**BASIN ELECTRIC
POWER COOPERATIVE**

Re: Basin Electric Power Cooperative
Williston Tie Project
PU-11-692 Application Amendment

Basin Electric Power Cooperative (Basin Electric) is proposing an amendment to the Application for a Consolidated Certificate of Corridor Compatibility (Corridor Certificate) and Route Permit for the Williston Tie Project (PU-11-692). The following sections describe the route alignment change and structure configuration change, as well as any differences this creates from the original Application.

Figure 2
Williston Tie-In Project
Route Revision Detail
 Basin Electric Power Cooperative

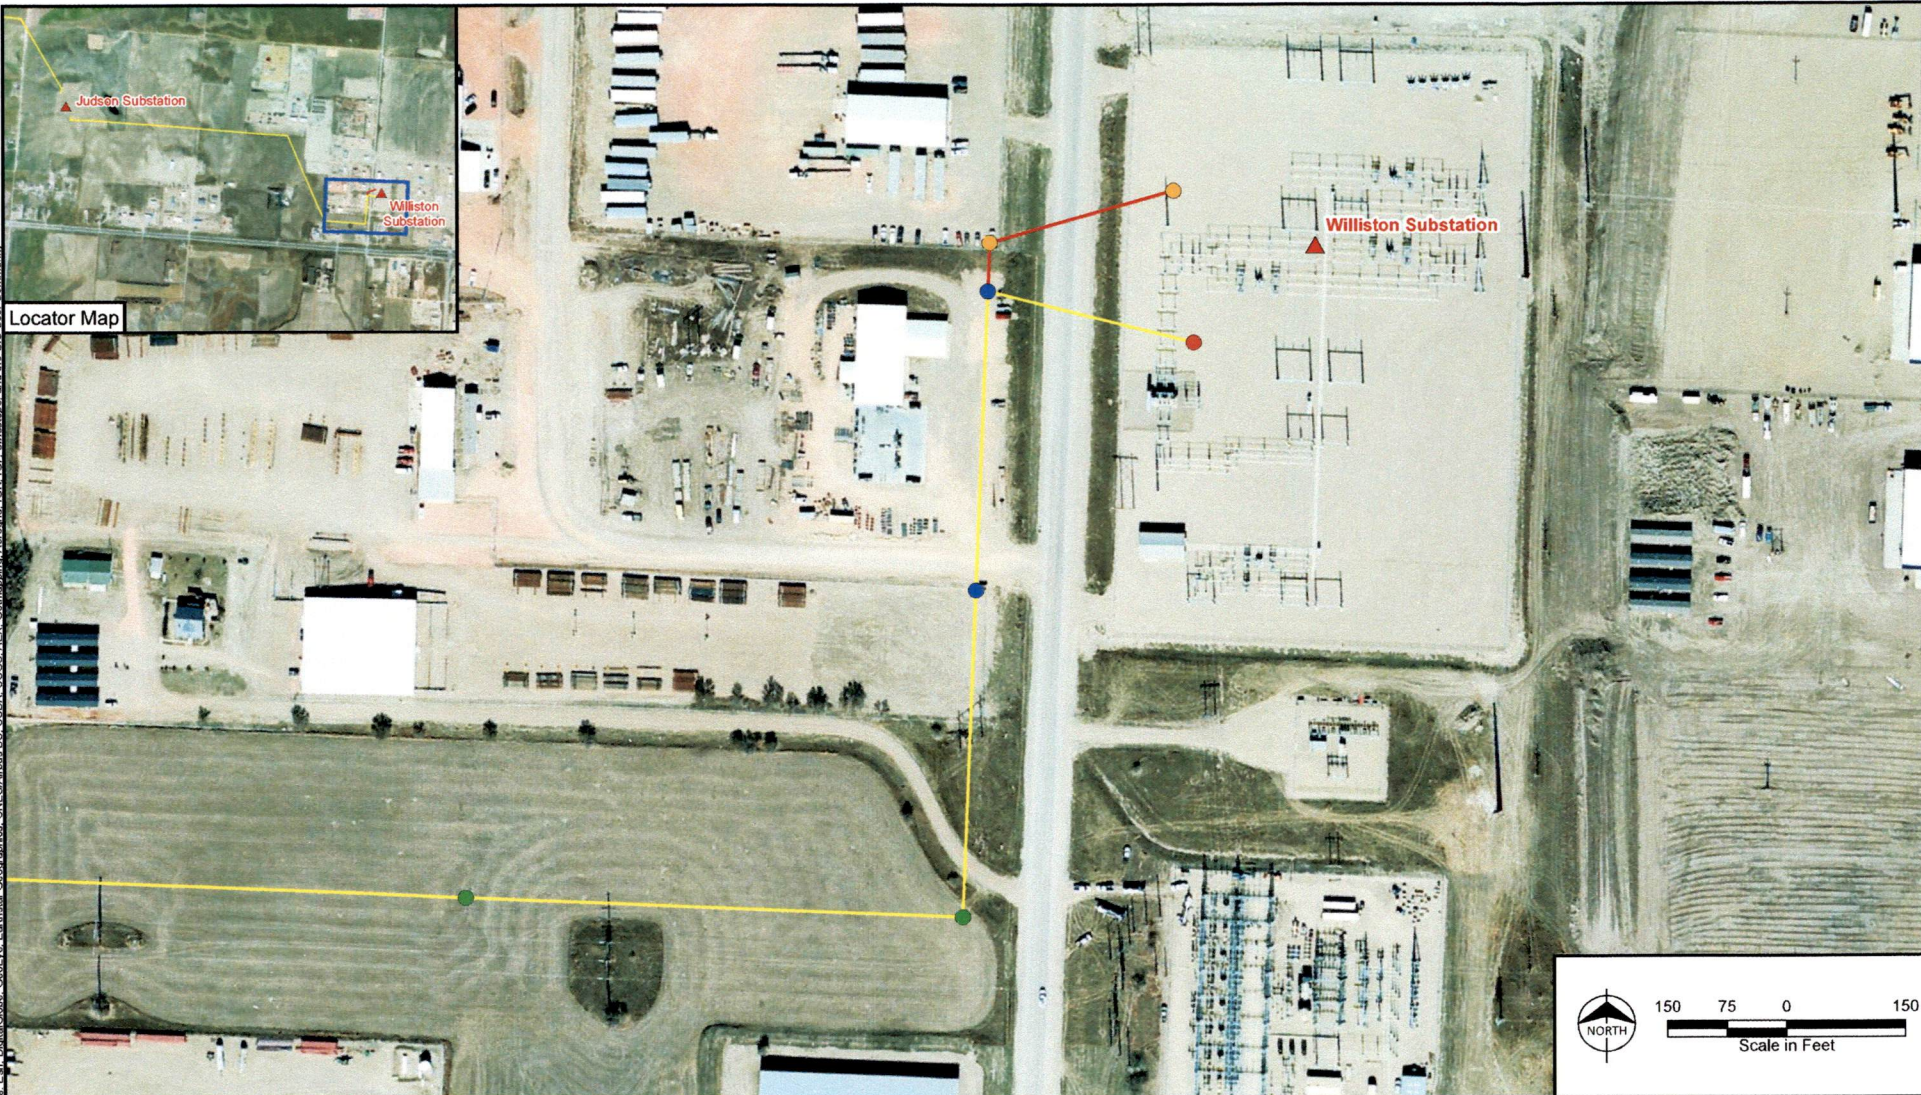
Following submittal of the January 2012 Application for the Project, and during the course of normal transmission line design, Basin Electric identified a minor adjustment to facilitate connection of the Project into the Williston Substation. In order to accommodate this connection, Segment C of the original alignment was shortened and the angle into the substation was reconfigured, resulting in the new, revised alignment (Figure 2 in the attachments).

The route revision extends through portions of two sections: Section 19 in T154N - R101W and Section 24 of T154N - R102W. If approved by the Commission, the total length of the Project would be approximately 34.5 feet shorter than the originally proposed alignment. The Corridor/Route revision does not alter the information presented in the original Application. The Corridor/Route revision is minor and typical of the progression of a linear project. Only siting criteria information that has changed because of the Corridor/Route revision is presented in this amendment. All other portions of the original Application remain in effect.

Figure 3
Williston Tie-In Project
Proposed 230/230 kV Structure

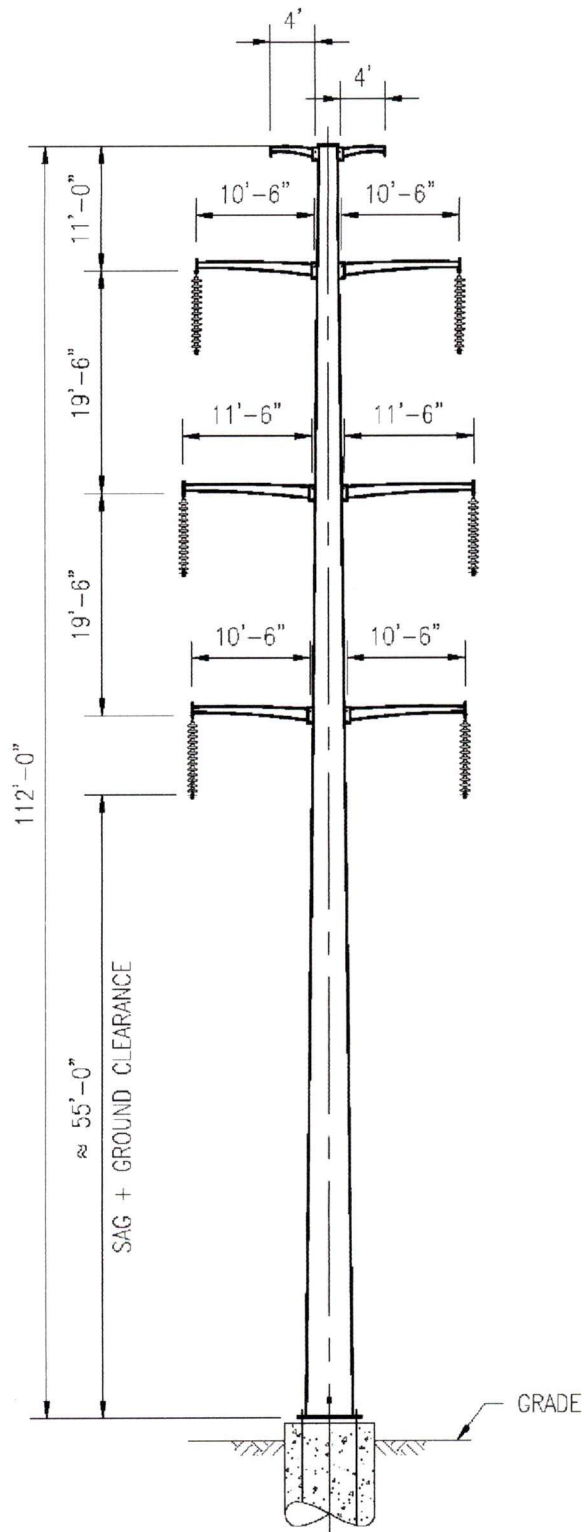
Following submittal of the January 2012 Application for the Project, through transmission planning discussions, Western Area Power Administration (Western) requested a portion of Segment C of the Project be designed and constructed to accommodate an additional 230-kV circuit. Western has future plans that require an additional interconnection into their 230-kV Williston Substation. By co-locating onto two structures of Segment C, Western and Basin Electric will minimize the impact on adjacent landowners and maintain an available Corridor/Route for future line substation connection. At such time as Western constructs their interconnection, they would extend a single circuit 230-kV line to the north prior to crossing County Road 4 (141st Avenue NW) into the Williston Substation. The 230/230-kV double circuit structure schematic is shown in Figure 3 attached. These structures would differ only slightly in appearance and height from the previous double circuit 230/115-kV and single circuit 230-kV structures previously proposed for Segment C.

- The use of the revised structure to a double circuit 230-kV configuration would help facilitate future Western expansion of its transmission system by providing a corridor/route for additional 230-kV connection to the Williston Substation.
